Section 16 Planning Application No. A/SK-PK/310

Response to Departmental Comments Table

Section 16 Application for Proposed Temporary Public Vehicle Park (Private Cars Only) with Ancillary Electric Vehicle Charging Facilities, Eating Place, Drivers Lounge and Solar Panels for a Period of 3 Years at Lots 333 S.B RP, 346, 348 RP, 349 RP and 350 in D.D. 221, Tai Mong Tsai Road, Sai Kung, New Territories

Annex 1a: Location of Site Photos

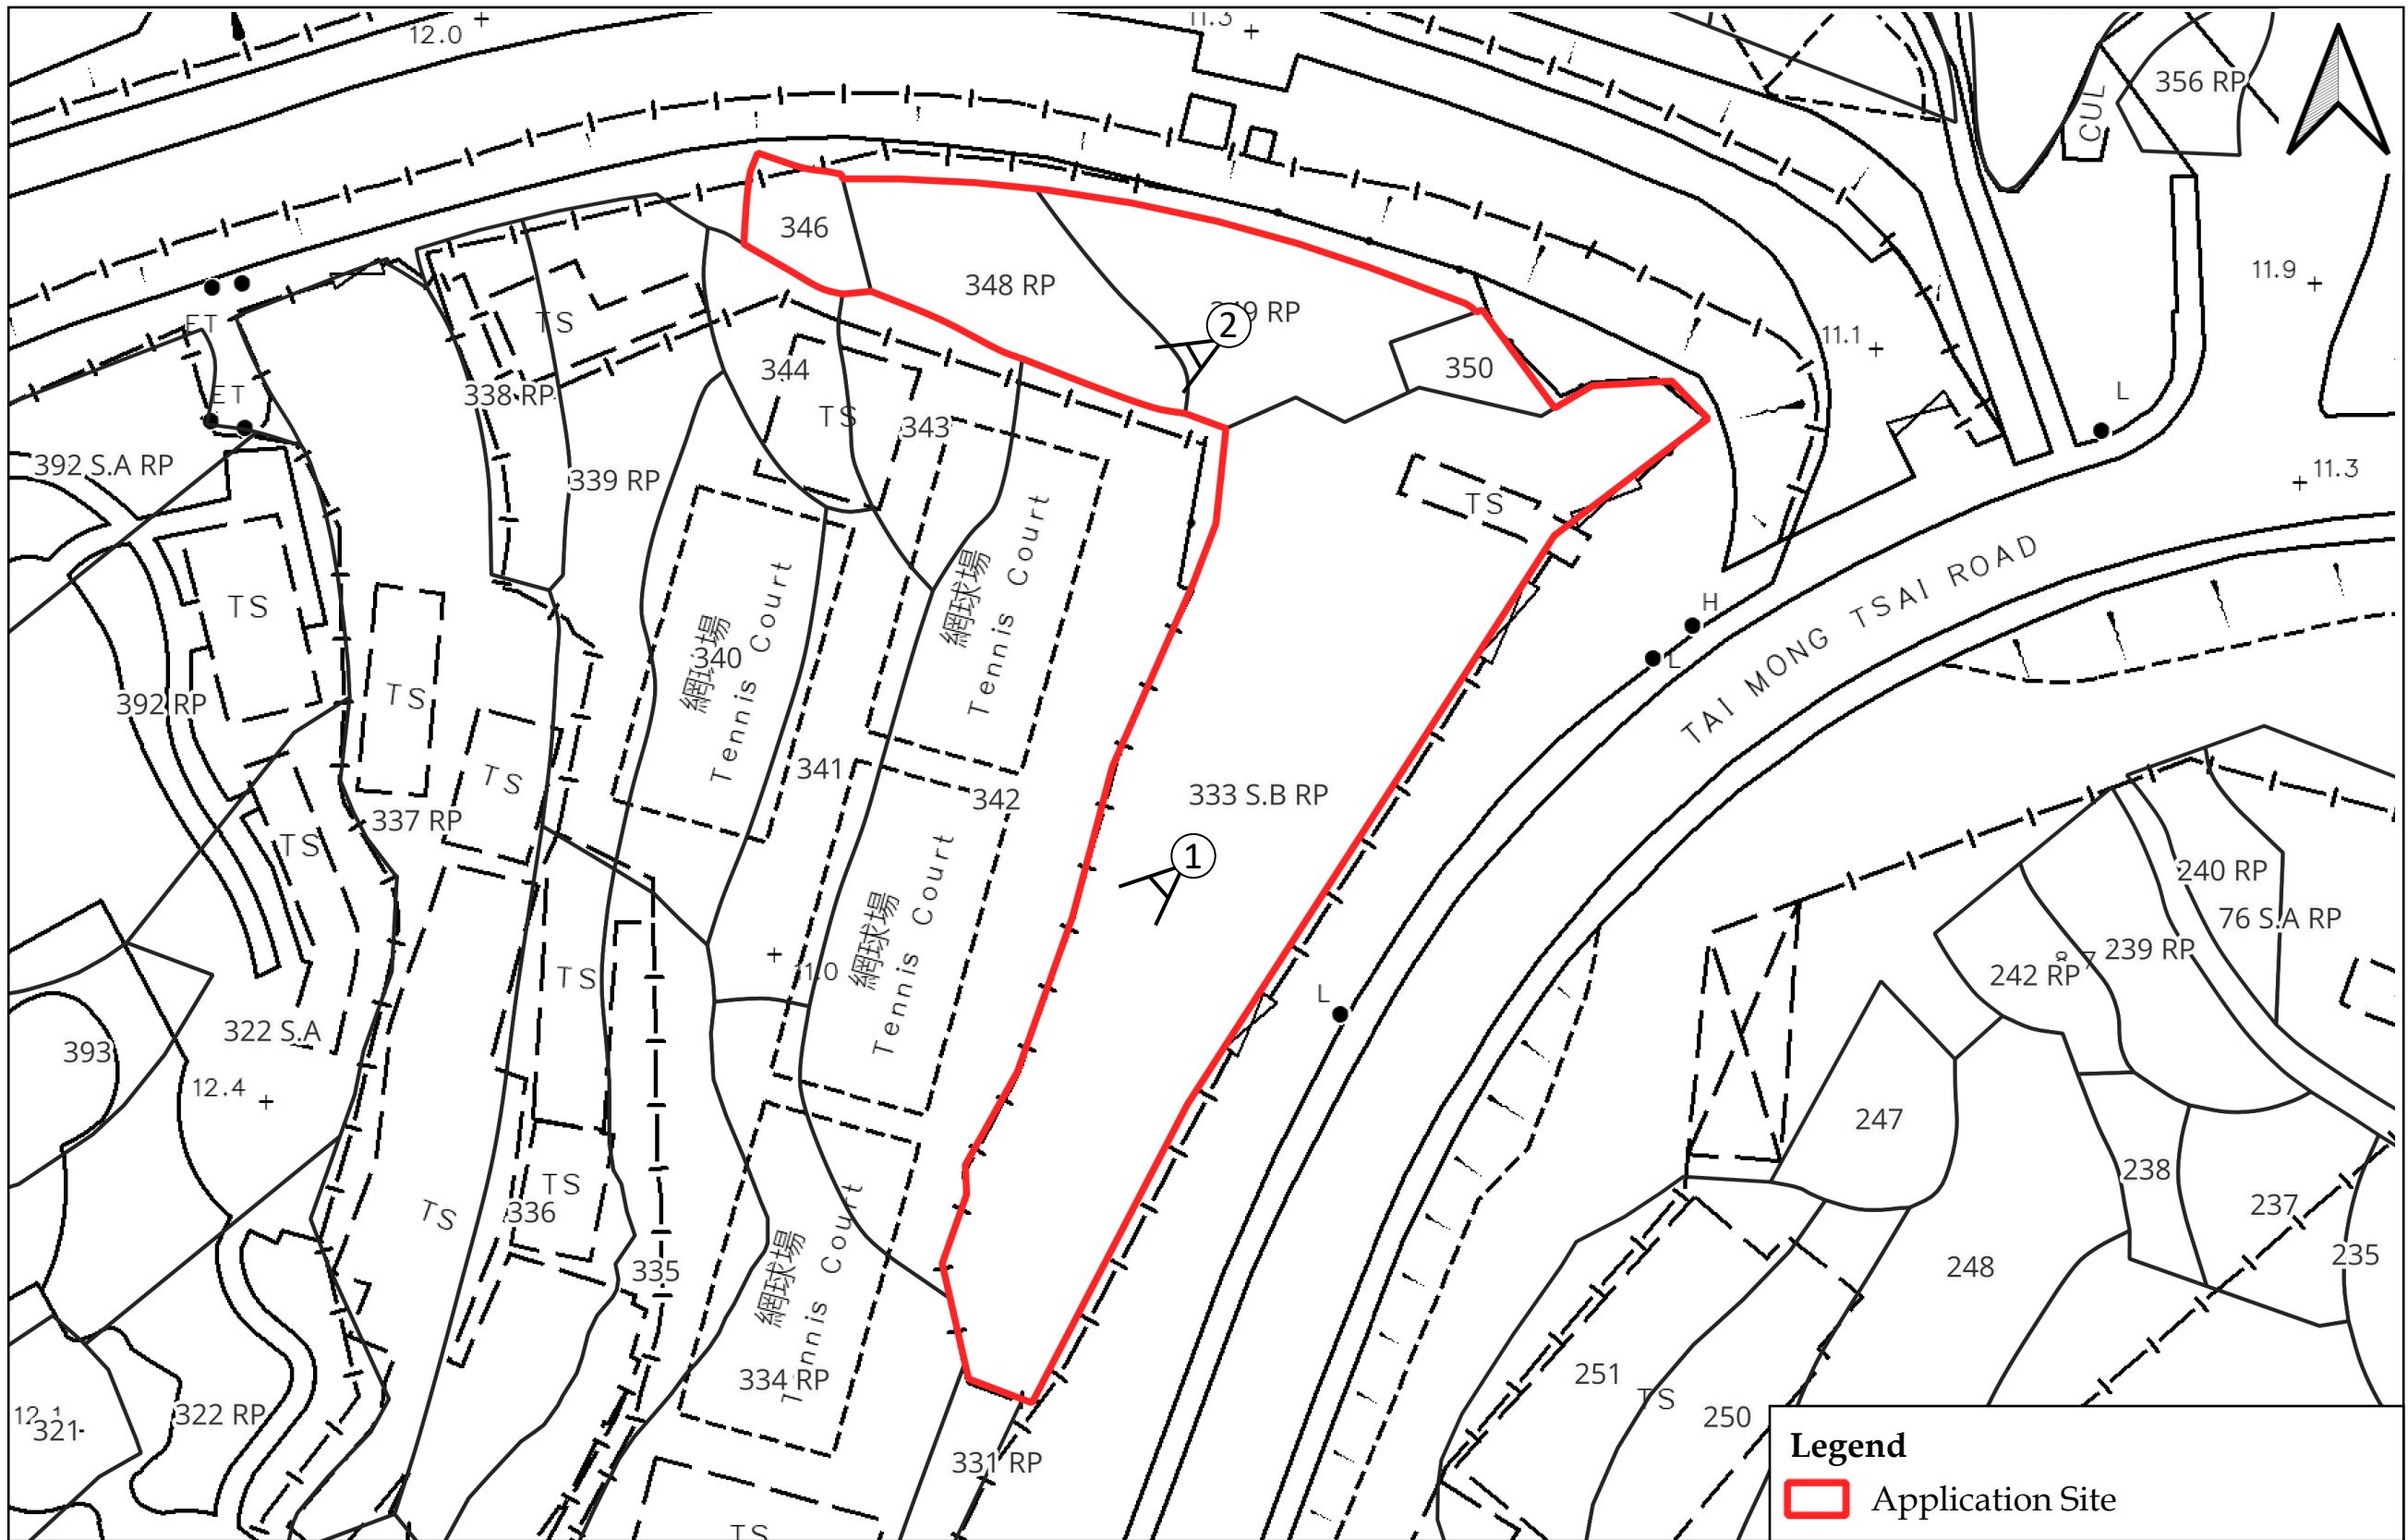
1.	Existing trees are found within the Site, but no trees information/ proposed treatment is provided in the application; and	As shown in Annexes 1a and 1b , all trees are falling outside of the boundary of the Application Site (the Site). No trees will be removed in the Site, and hence no mitigation measures are required.

Figure 4 : Revised Indicative Layout Plan

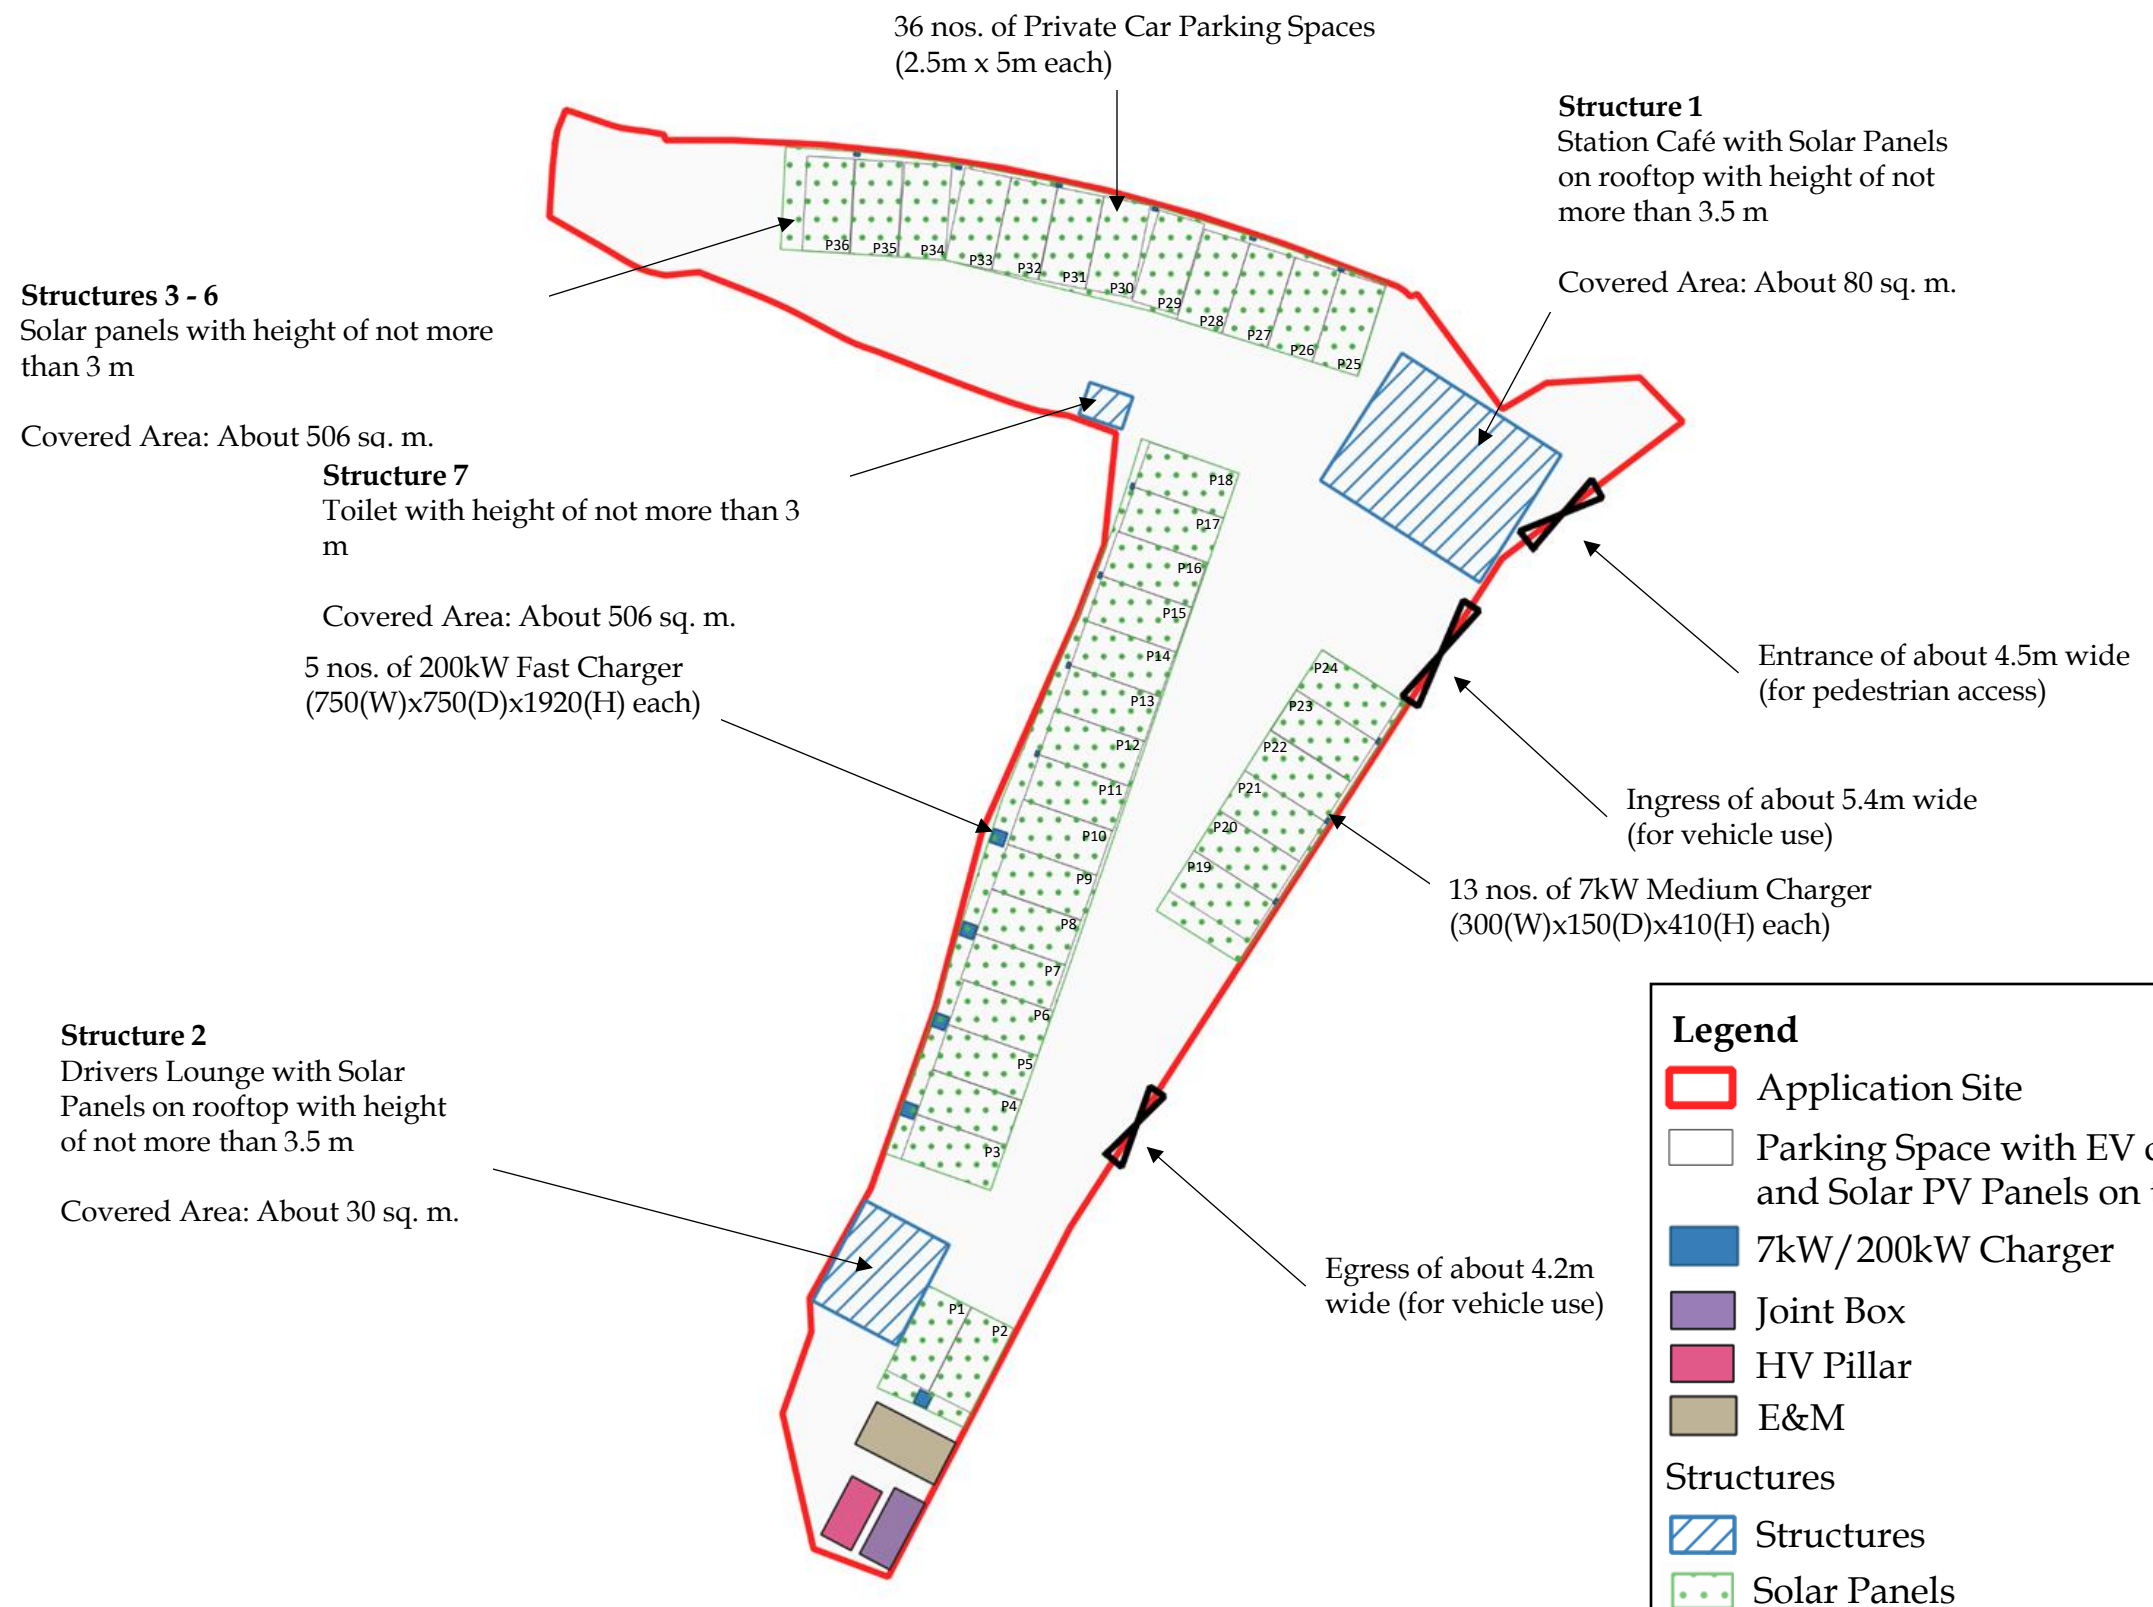
4.	It is noted from Section 3.5.1 of the Planning Statement that the applicant proposed to provide 36 private car (PC) parking spaces. 10 of them will be 200kW charging points and the remaining will be 7kW charging points. Please amend Figure 4 in "A_SK-PK_310_Plans" accordingly to reflect the above EV charger information;	All the 7kW and 200kW charging points will be shared by two parking spaces. Hence, only 18 chargers will be installed in the Site.

11.	Should planning approval be given to the subject planning application, the owners of the lots without Short Tem Waiver (STW) will need to apply to this office for an STW to permit the structures to be erected on site, if any. Given the proposed use is temporary in nature, only application for erection of temporary structures will be considered. The application will be considered by LandsD acting in the capacity as landlord at its sole discretion and there is no guarantee that such application will be approved. If such application is approved, it will be subject to such terms and conditions as may be imposed by LandsD including the payment of fee as considered appropriate; and	Comment noted. Upon approval of this planning application, the existing structure near the ingress point of the Site will be removed and a Short Term Waiver application will be submitted for the structures proposed in the revised layout plan at Annex 2 .
